TOWN OF JEROME

Zoning Administrator Analysis Design Review Board Tuesday, May 27, 2025

Location: 879 Hampshire Blvd
Applicant/Owner: Verde Exploration Ltd
Zone: I-1
APN: 401-11-021A
Prepared by: Will Blodgett, Zoning Administrator
Recommendation: Recommend discussion / approval

Project Description: Garage Door reconfiguration with new walk in entry

879 HAMPSHIRE STUDIO B108

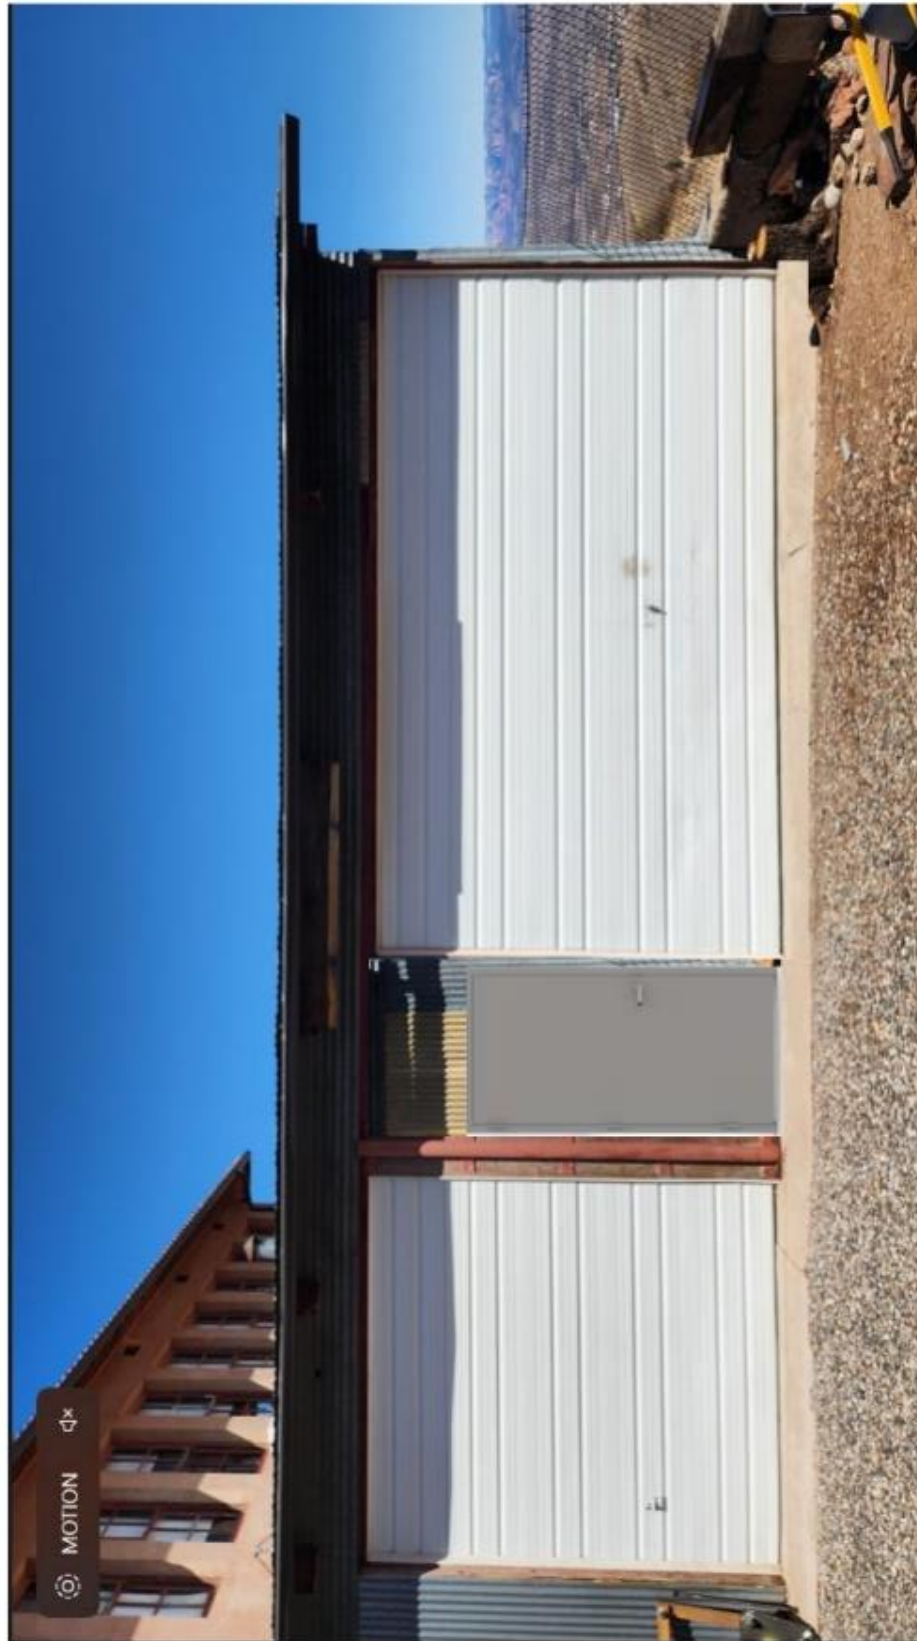
Response: The proposed part of the structure under review is a Garage-addition to Building B. Initially designed with two roll-up garage doors as the primary access, the applicant wishes to add a single, standard pedestrian entrance between the two existing roll-up doors, and move one of the roll-up doors to the east in order to accommodate. The way this addition was constructed does not make this wall, or this opening structurally integral, and thus only Design Review is being required.

- The front exterior wall of studio B-108 will be re-configured to move the existing roll up double garage door approximately 5 feet to the right as shown on the “Proposed Configuration” exhibit.
- The existing exterior tin siding will be salvaged and reused along with matching vintage tin as needed to replace areas previously patched with tan fiberglass. The tin to be used was salvaged from other old Jerome structures and is in storage at the mine yard property on Douglas Road.
- A 36-inch steel slab entry door will be added to the left of the roll up garage door. The door will be either industrial gray as shown or painted red to match existing trim at the high school. There is no plan to change the color of the roll up garage door(s).

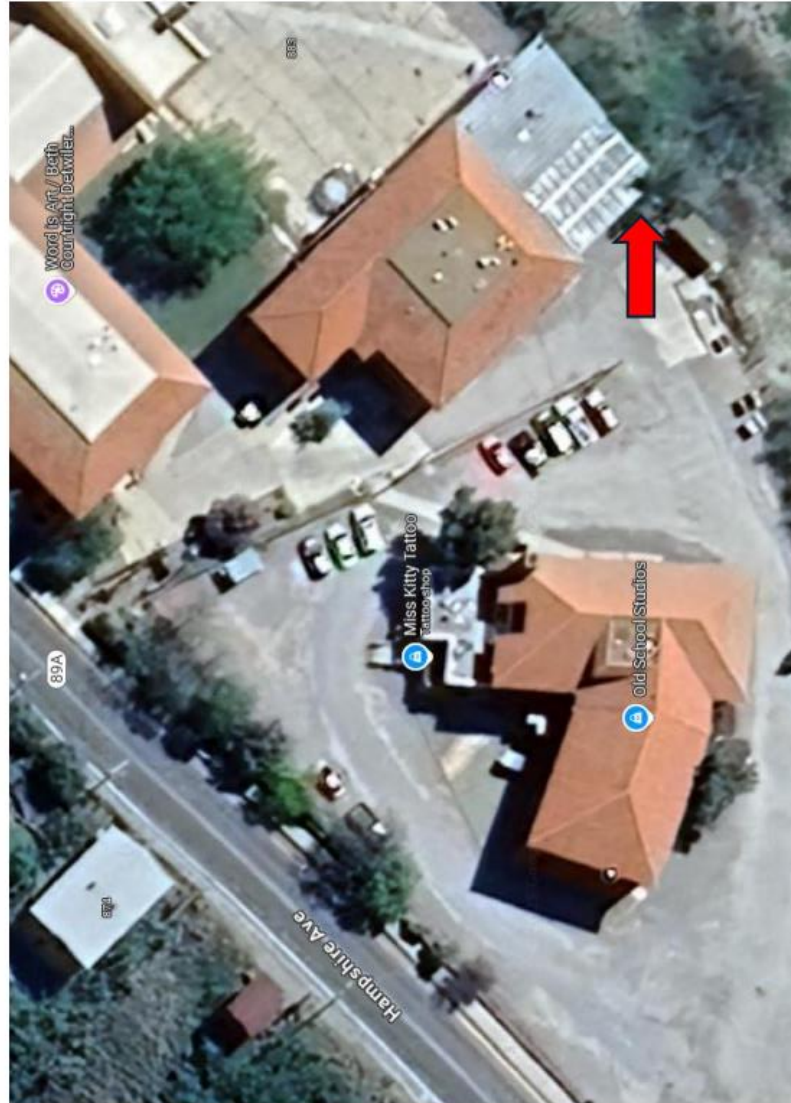
The tin garage is an early 1960's addition to the automotive shop garage at the rear of Building B while in use by the Mingus Union High School District. The footprint of the tin addition is denoted by the roofing pattern with white/gray. The solid gray roof is the original automotive garage addition and is one of two additions to the Building B footprint that were made prior to 1940 while in use by the Jerome High School.

The scope of this project is limited to the west exterior wall of the tin garage (see red arrow).
